# UNITED STATES PATENT AND TRADEMARK OFFICE

APPLICATION NO.	FILING DATE	FIRST NAMED INVENTOR	ATTORNEY DOCKET NO.	CONFIRMATION NO.
10/714,372	11/17/2003	Bradford D. Remole	413TD	1847

# Office Action Summary

EXAMINER'S MARK-UP RELATIVE TO OFFICE ACTION  
ON SER. NO. 10/714 372

FIG. 1

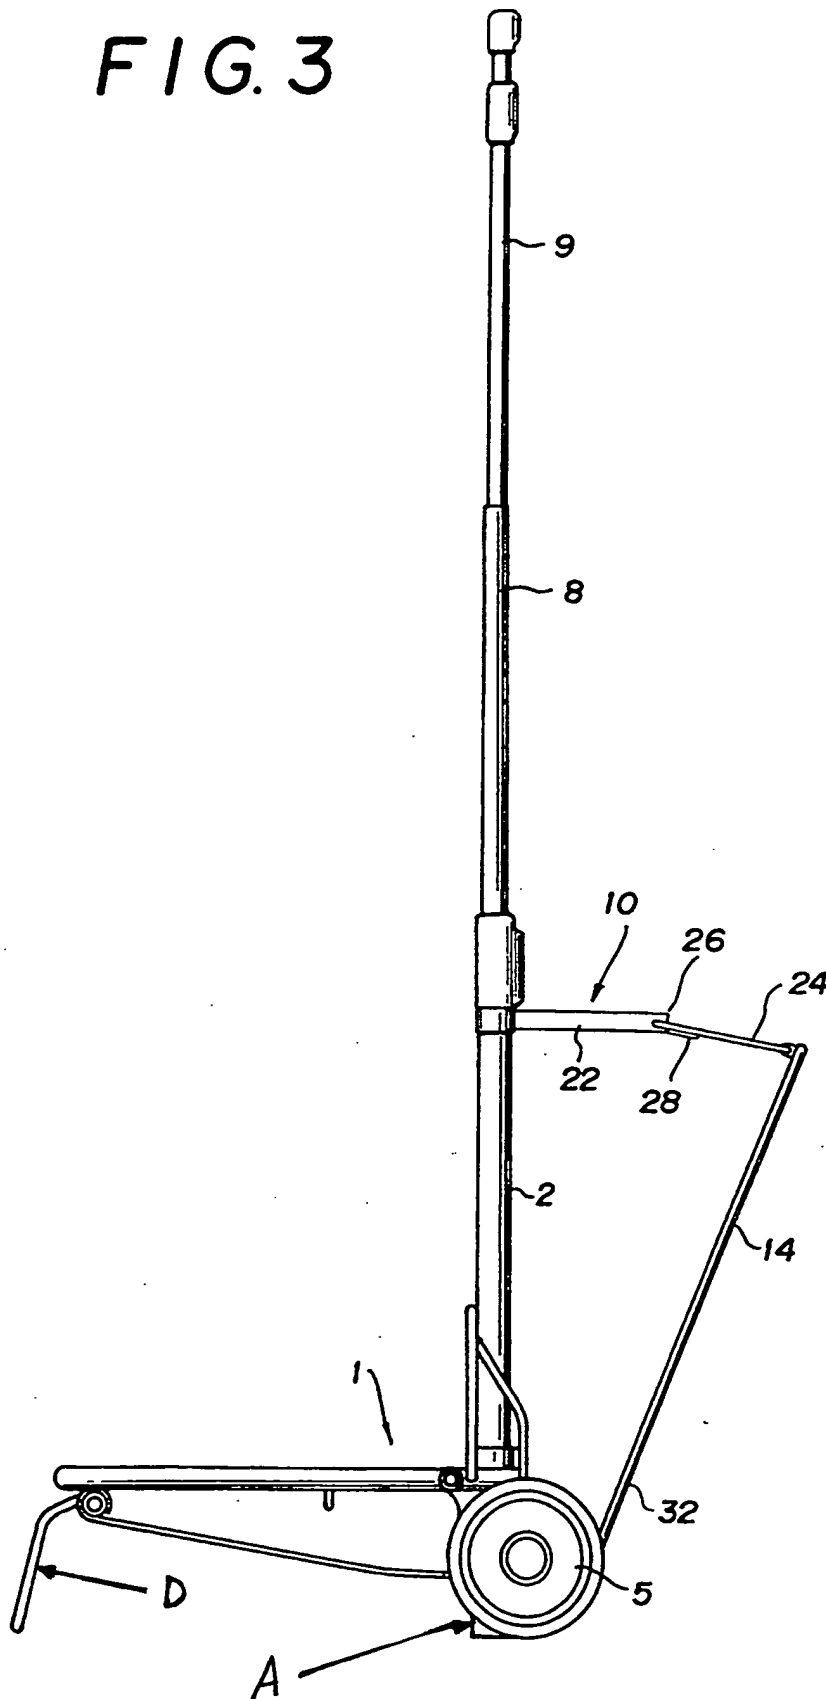
a.) a frame composed of a pair of spaced-apart tubular, elongated members (Fig 1, items 2, 3) with a U-shaped handle member (refer to the shape of the handle as shown in Fig 4) having a pair of free legs (items 9, left and right) for engagement with a first end (taken as the top end) of the tubular members (2, 3);

b.) the elongated members (2, 3) having second ends (taken as their not-separately-numbered bottom ends, labeled as items “A” and “B” in the Examiner’s Mark-up of Figures 1, and 3-5, attached hereto) joined together by a fixed bracing support (taken as the Examiner’s Mark-up of Fig 1 as item “C”), the second (that is, bottom) ends further provided with rotatable wheels (5) spaced vertically along the elongated members (as clearly understood from Fig 4);

c.) a pivotal platform Fig 1, item 4) hingedly mounted to the tubular members along a midpoint of the tubular members (best understood from Figs 3 and 5), the pivotal platform mounting a pivotal leg (item “D” in the Examiner’s Mark-up of Figs 1 and 3-5) remote from the

**FIG. 3**

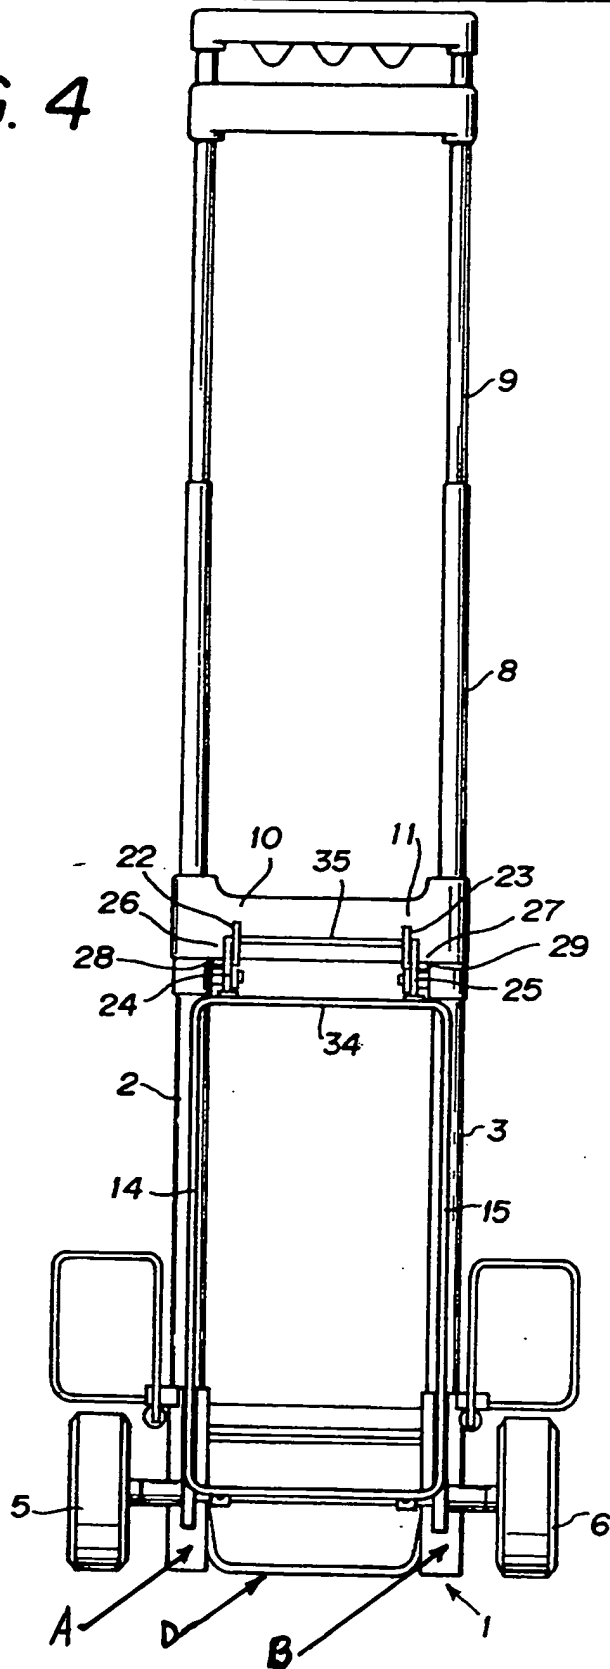
tubular members (2, 3) and extendable from a position adjacent to the platform (refer Fig 5) to a position perpendicular thereto (refer Fig 3); and
